**Report: Pinehaven Stream**  
**ARI 100 Hydrological Assessment**  
**Various Development Scenarios**

**Prepared For:** Save Our Hills (Upper Hutt) Incorporated  
**Author:** Robert Hall, R J Hall and Associates Ltd  
**Revision:** FINAL (and signed)  
**Date:** 05 November 2019

*Figure 5 - Beca "Pinehaven Stream Flood Mapping Audit" (13 July 2015)  
Sub-catchment B Hydrographs - Existing Hydrographs (OS1, with Climate Change (CC) and Future (DS1, with CC))*

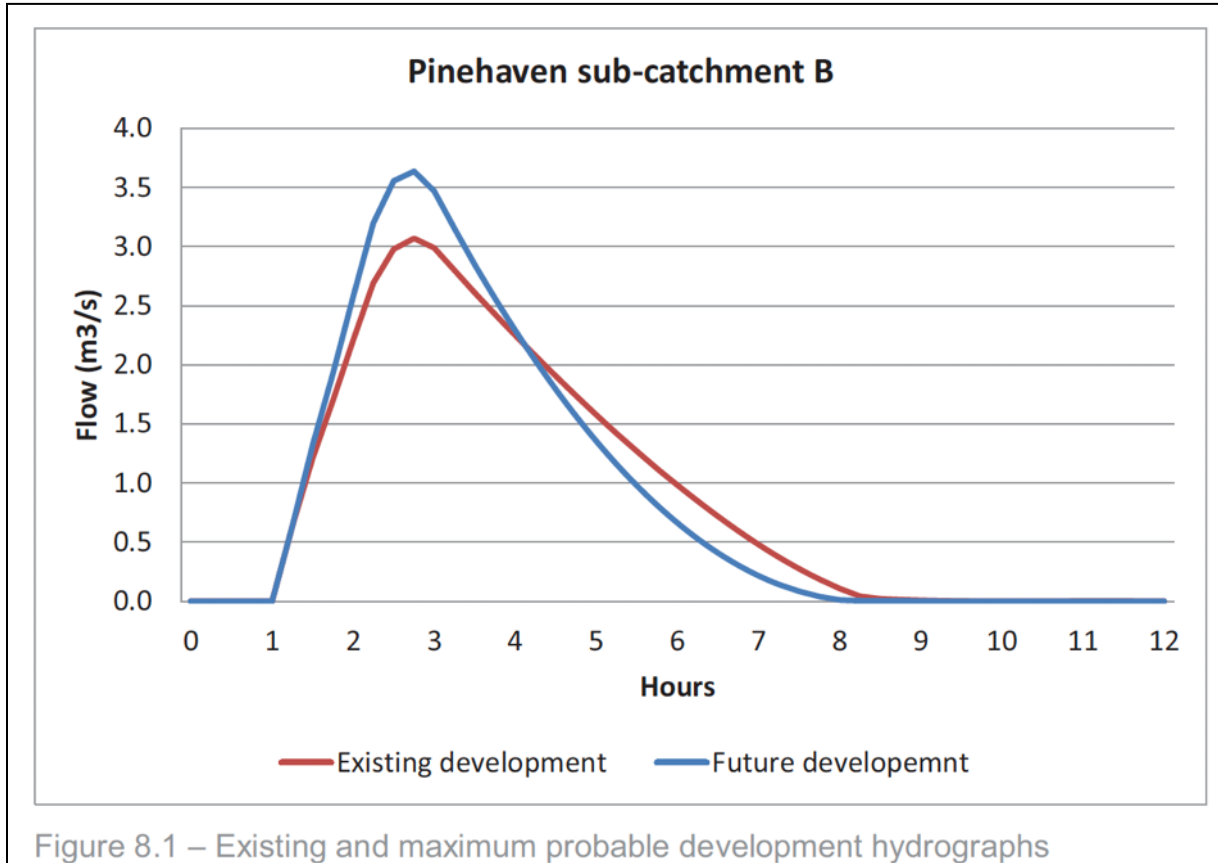
An audit by Michael Law (Beca, 2015) provided pre- and post-development [DS1] hydrographs for sub-catchment B (Figure 5) and estimated the increase in post-development [DS1] peak flow to be 18%, with the runoff volume increasing 5.6%.

*"Figure 8.1 [see RJH Figure 5] shows the change in flood hydrographs for existing development ... and future development ... for sub-catchment B, which is in the southwest of the catchment and drains to the top of Pinehaven Road. Future development increases the peak flow by 18% (from 3.07 m<sup>3</sup>/s to 3.64 m<sup>3</sup>/s), ... However, **the flood volume does not increase. This is unexpected, as increasing the impervious area of sub-catchment by 40% to reflect the development would be expected to reduce rainfall losses and increase runoff volume.** Similar results were found for sub-catchment E, which drains to Wyndham Road. Assuming a 100-year ARI plus climate change rainfall depth of 87.1 mm for the 3-hour storm, an Initial Loss of 5mm, Ongoing Loss of 2mm/hr, and 40% impermeable area for the affected post-development sub-catchments, then **the effective rainfall depths would be 76.7mm (88%) for existing land use, 80.8mm (93%) for post-development land use ... only 5.6% increase in effective rainfall post-development. ...***

**The difference between existing and post-development flood volumes would be expected to be a similar ratio.** ... The issue of no increase in post-development flood volume was raised with MWH, but they have not been able to provide an explanation as to why there is not an increase in flood volume. While this does not affect the validity of flood extents defined for current development, **it does invalidate the post-development flood extents and reduces community confidence in the flood mapping process.**” Beca “Pinehaven Stream Flood Mapping Audit” 2015, pp26,27 – (emphasis by RJ Hall & Assoc. Ltd)

Figure 14 - Pre and Post Development OS1 and DS1 Hydrograph Comparison (Jacobs, 2016 and R.J.Hall and Associates Ltd, 2019)

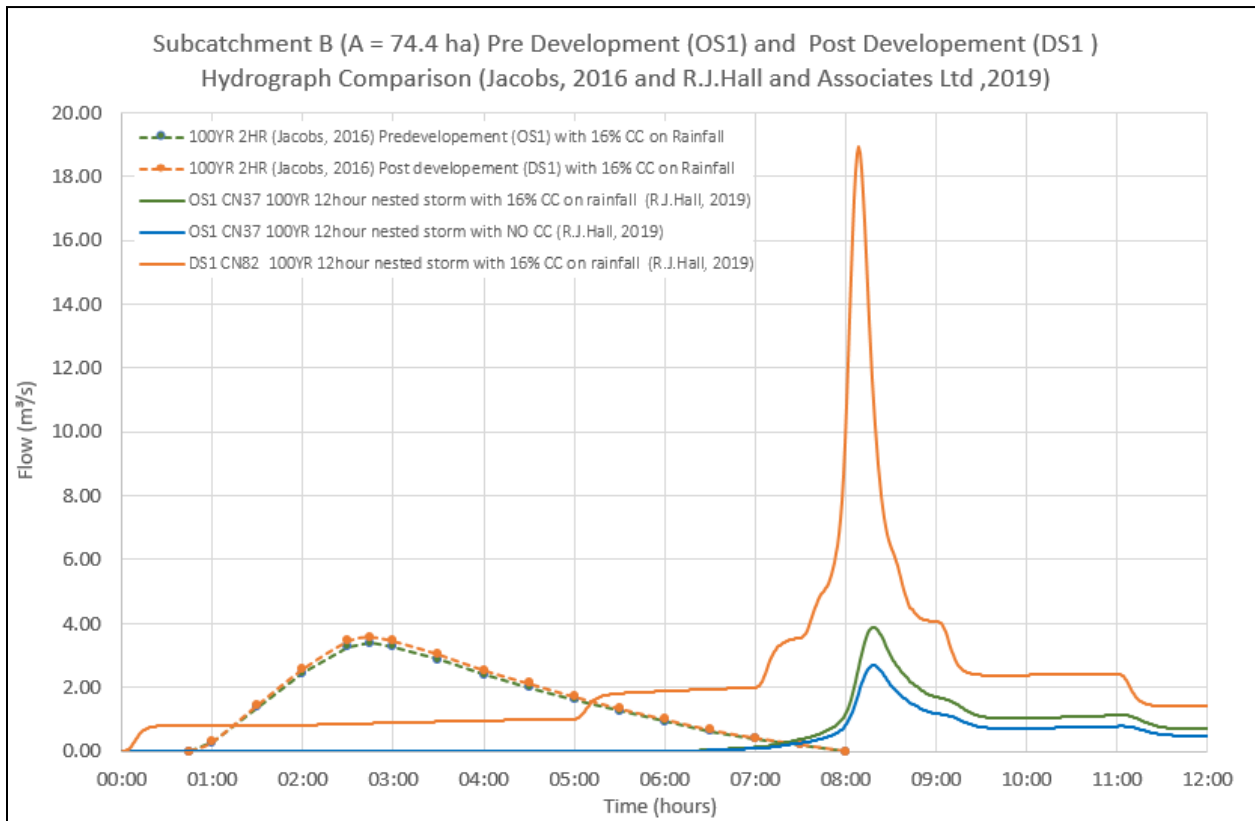
that the unmitigated effects that will be generated are likely to be minor where in reality that will not be the case (refer section 4.0 and Figure 14);
